GREAT SHERBORN DESIGN INC.	
241 RO 4E MILLBROOK, CT. 06040	
FOR	
DR. TIM HENNING &	
CL. AND VOLK-HENNING	
POPTHILL, CT.	
DATE	JULY 6, 1990
SCALE	1/4" = 1'-0"
ALL	A-4

LANDSCAPE PLAN

MEDICAL BUILDING DELHAM RD. SOUTH		
SCALE: AS SHOWN	APPROVED BY:	DRAWN BY: B. FREAR
DATE: DEC/90		REVISED
TIMBER WALL PLAN, ELEVATION & DETAIL SECTION.

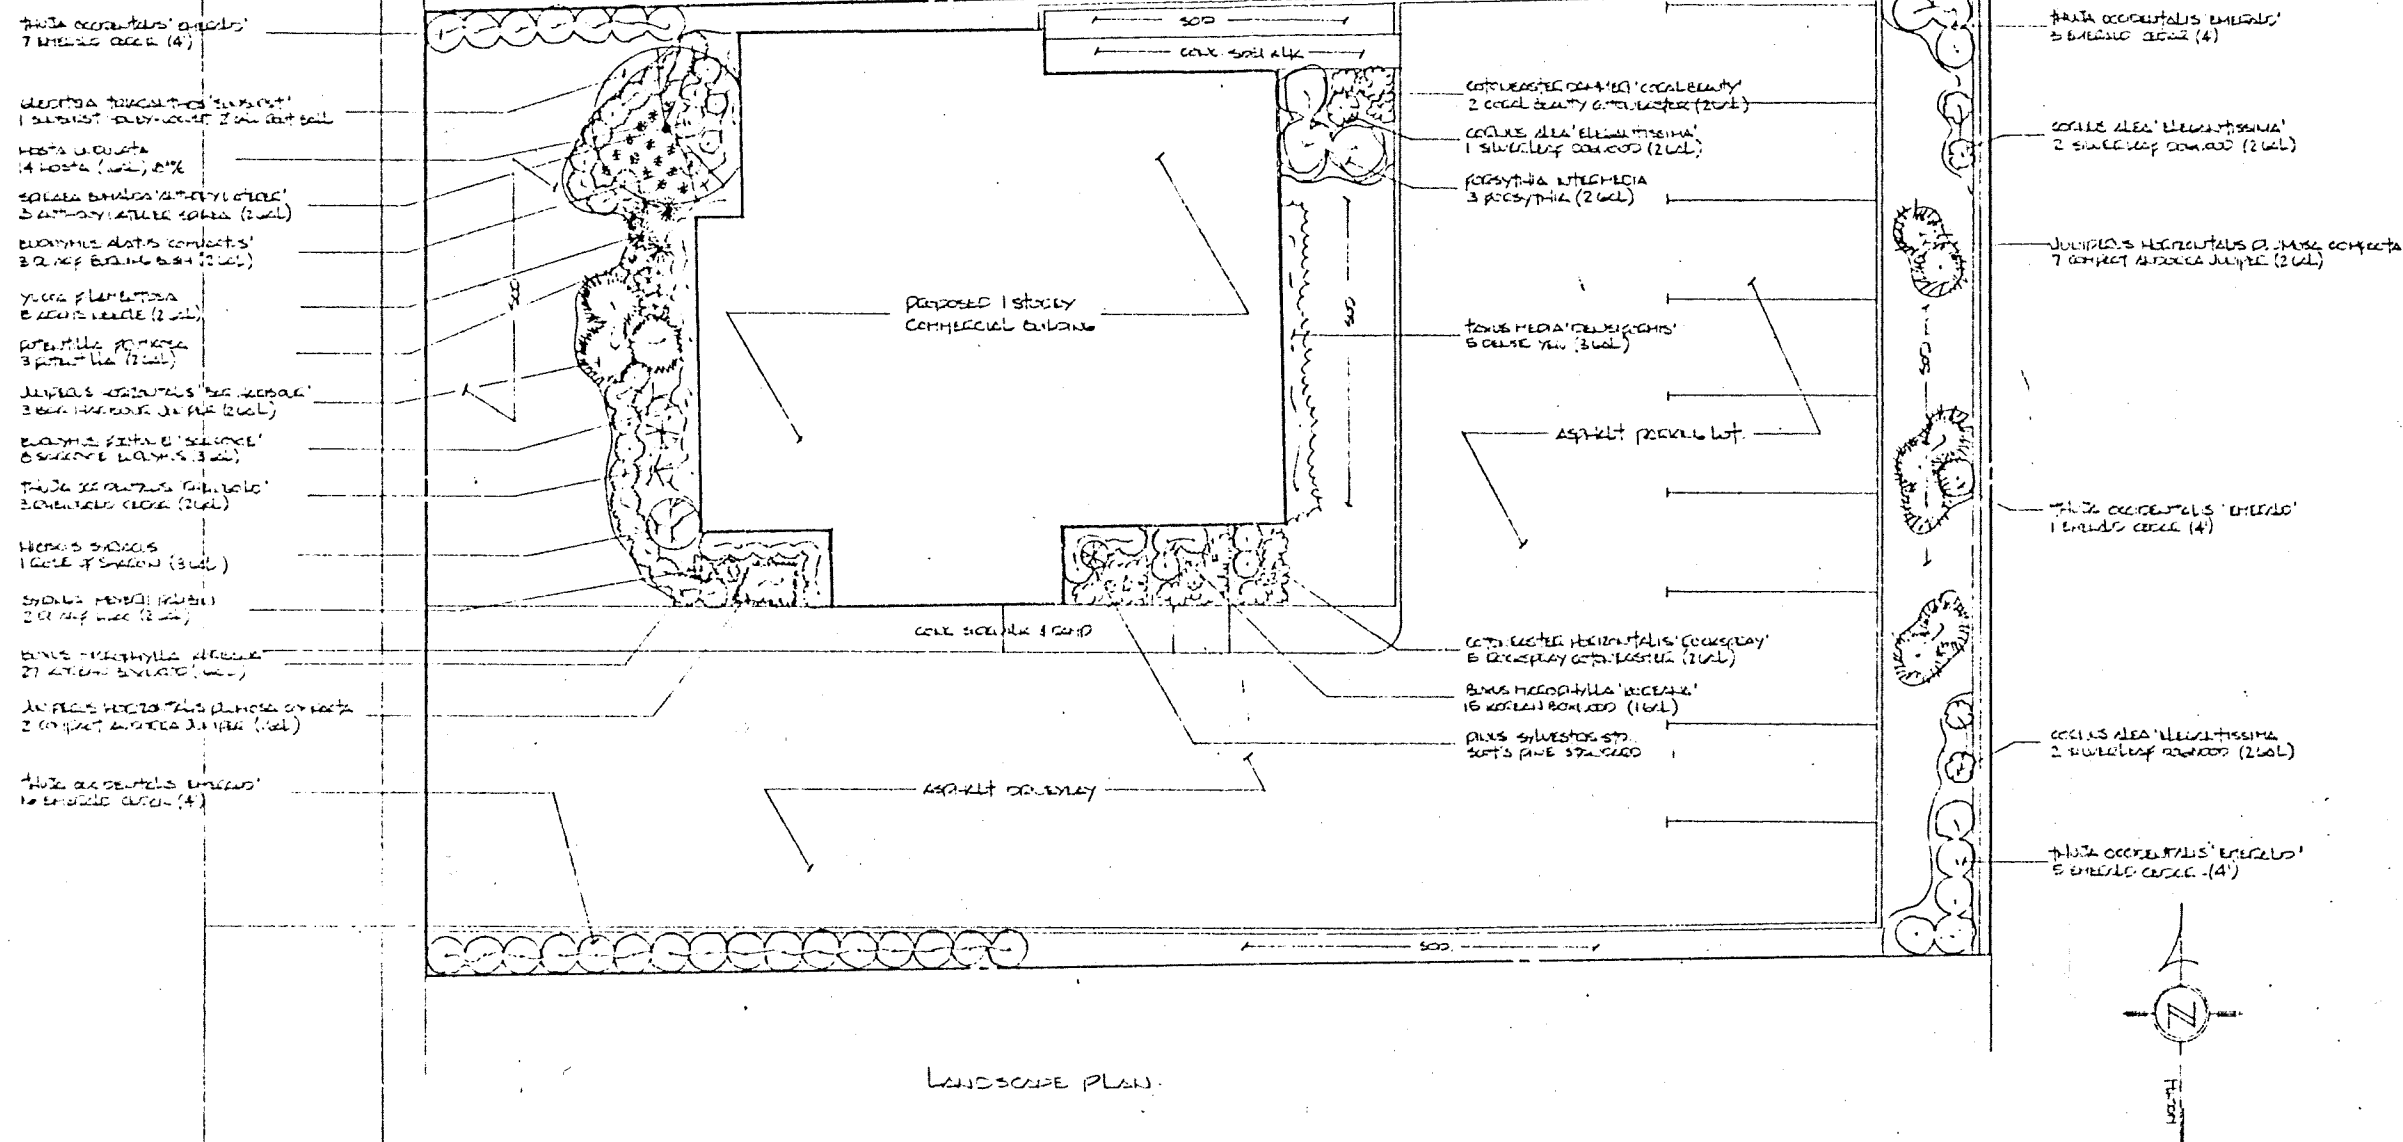
Comments:
1. Also 22' 00" plan CE again to accommodate changes
from parking area & building footprint
